SOLICITATION AMENDMENT
MODIFICATION DE L'INVITATION

Title - Sujet ROLLING MILL	
Solicitation No. - N° de l'invitation 23584-130012/A	Amendment No. - N° modif. 004
Client Reference No. - N° de référence du client 23584-130012	Date 2012-06-05
GETS Reference No. - N° de référence de SEAG PW-\$\$HN-445-60428	
File No. - N° de dossier hn445.23584-130012	CCC No./N° CCC - FMS No./N° VME
Solicitation Closes - L'invitation prend fin at - à 02:00 PM on - le 2012-06-27	
F.O.B. - F.A.B. Plant-Usine: <input type="checkbox"/> Destination: <input checked="" type="checkbox"/> Other-Autre: <input type="checkbox"/>	
Address Enquiries to: - Adresser toutes questions à: Ladouceur, Joanne M.	Buyer Id - Id de l'acheteur hn445
Telephone No. - N° de téléphone (819) 956-3587 ()	FAX No. - N° de FAX () -
Destination - of Goods, Services, and Construction: Destination - des biens, services et construction:

This amendment 004 is raised to provide a response to a supplier enquiry and to extend the closing date to June 27, 2012. The question and response are provided as follows:

FRONT VIEW

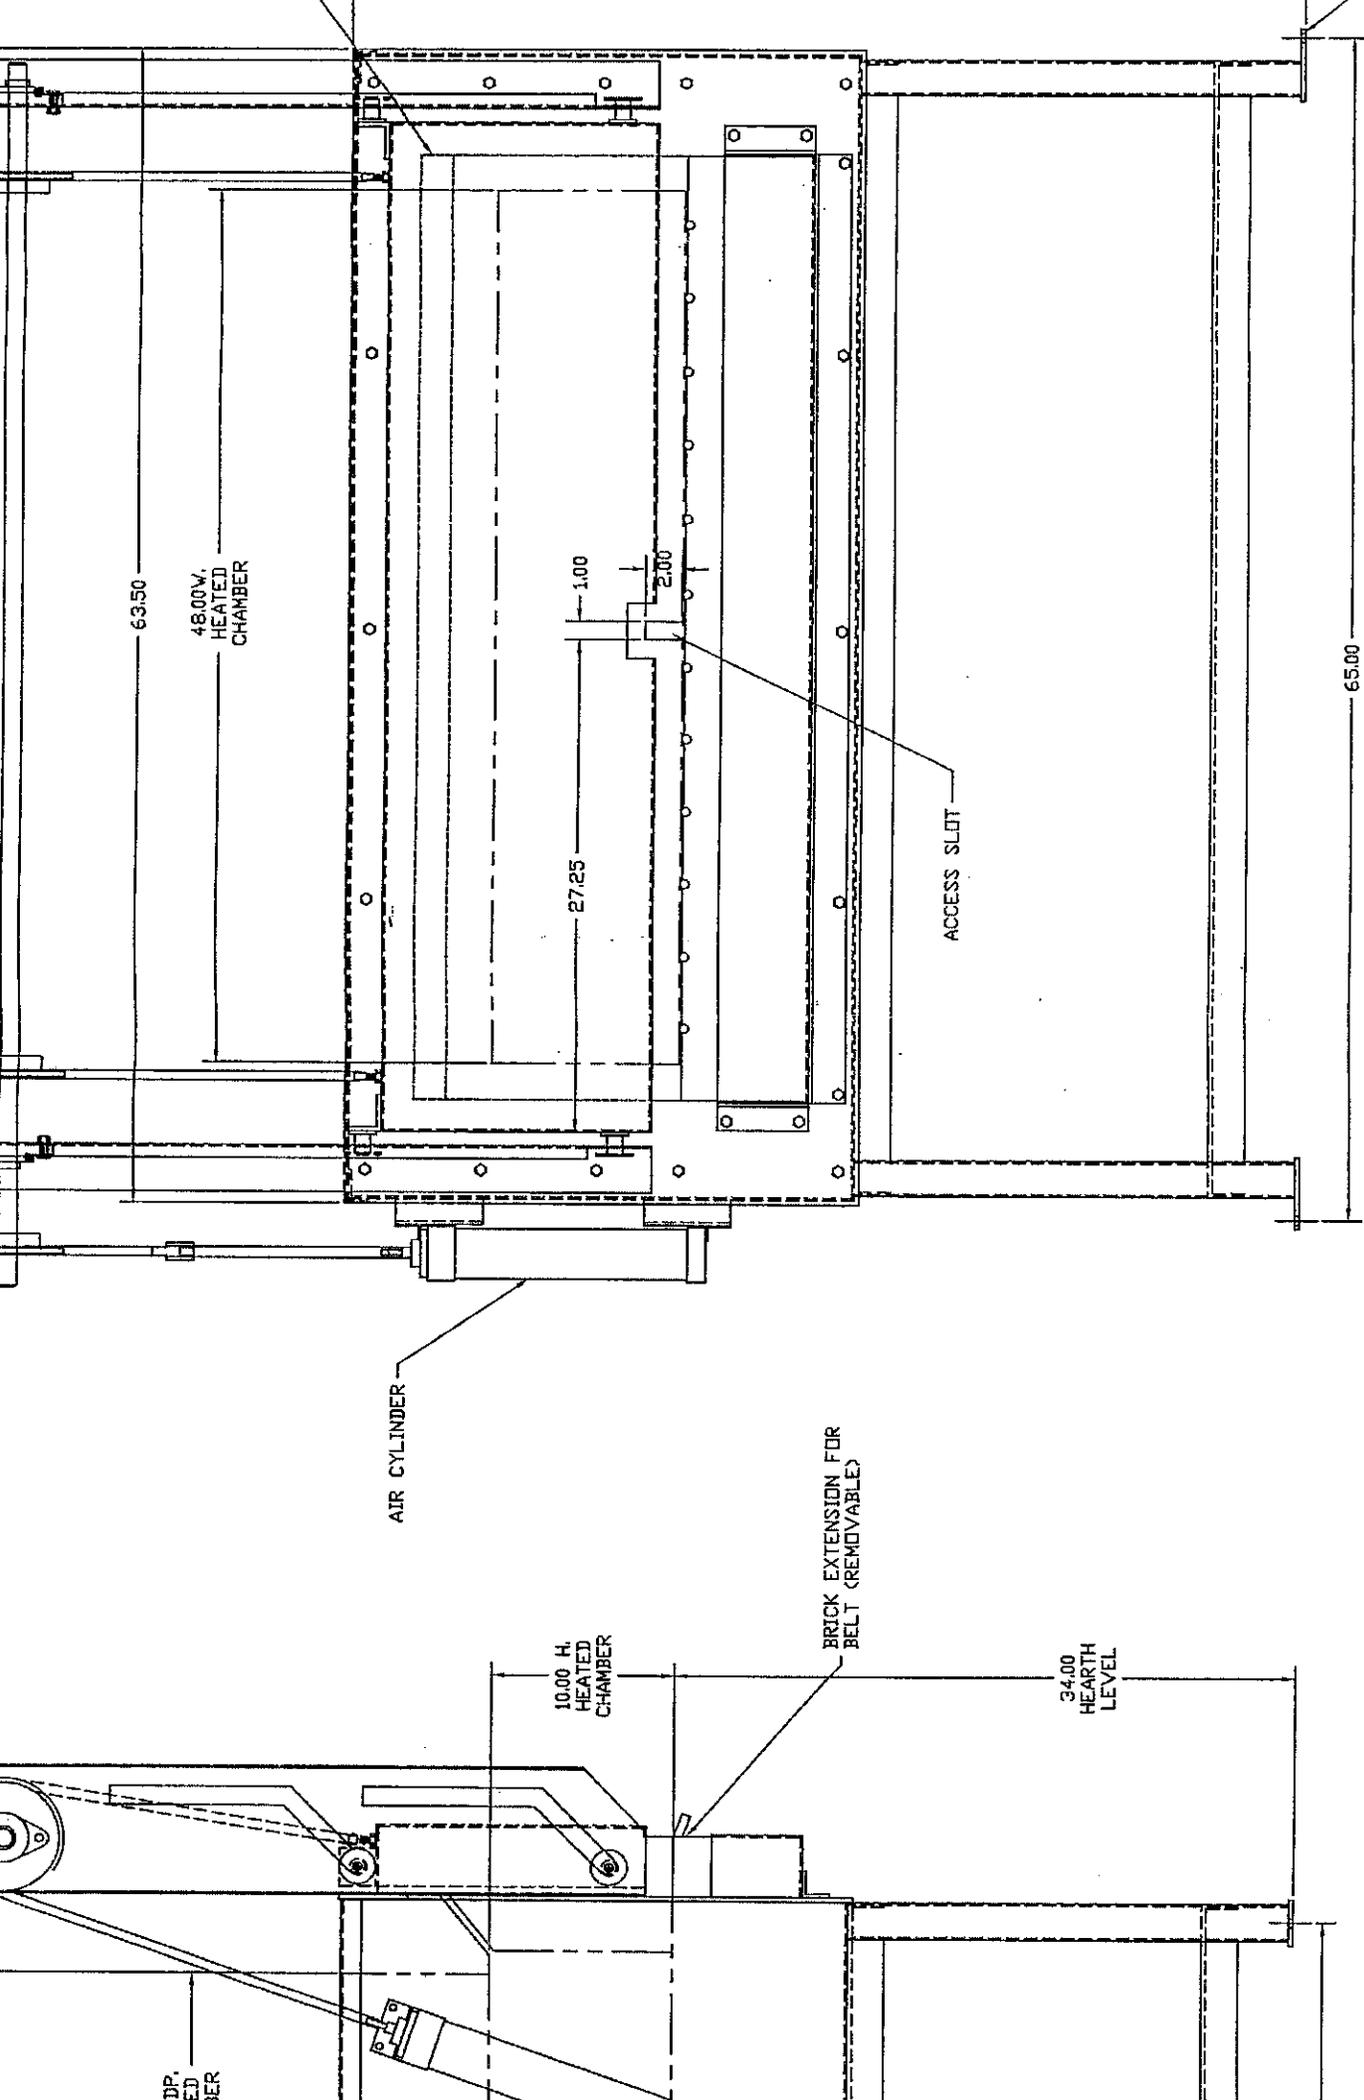
=====
Question: We do not quite understand the working below, do you require two manipulator, please confirm? Also do you have drawings of the furnace so we can determine how to get under the ingot to hold it with the manipulator?

- 12.) Q:** How many manipulators are required? A furnace drawing has been required.
A: Two manipulators are required, one on each side of the mill. Furnace drawing attached.

Response: Two manipulators are required. One on each side of the mill. Thermcraft furnace drawings attached.
